Review of the Re-circulated Draft Environmental Impact Report (Draft EIR) for the Santa Clarita Valley Area Plan Update

Re: Santa Clarita Area Plan Update R2007-0126, Plan Amendment 2009-0006 and
associated permits – One Valley One Vision

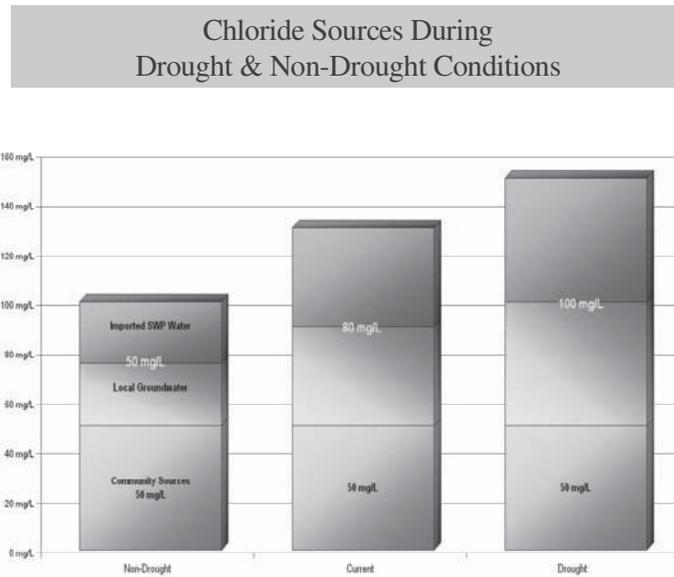
The Santa Clarita Sanitation Districts’ failure to meet the Clean Water TMDL standard for chloride of 100mg/l in the Santa Clara River is a result in part to the sharp and continuing increase in the use of imported State Water Project (SWP) water as seen by the chart below, (from the Sanitation Districts).

While the Plan itself describes this problem, the DEIR fails to accurately disclose the extent of the impact from new building. Thus, the Plan will exacerbate the problem while failing to provide a goal or policy to address it. Further, there is no proposed funding mechanism to pay for the needed improvement upgrades to lower the chloride levels or to pay for the fines that will be imposed if the Sanitation Districts violate the Clean Water Act by not complying with the established Chloride TMDL.

- The Plan must include a timeline and funding mechanism to provide compliance with the Clean Water Act TMDL for Chlorides and other pollutants such as bacteria described in the Plan.
- Mitigation measures that require chloride elimination for all future sanitation district connections must be required.
- Funding for upgrades to the Sanitation plants to eliminate chloride from the effluent released to the Santa Clara River must be included in new connection fees.
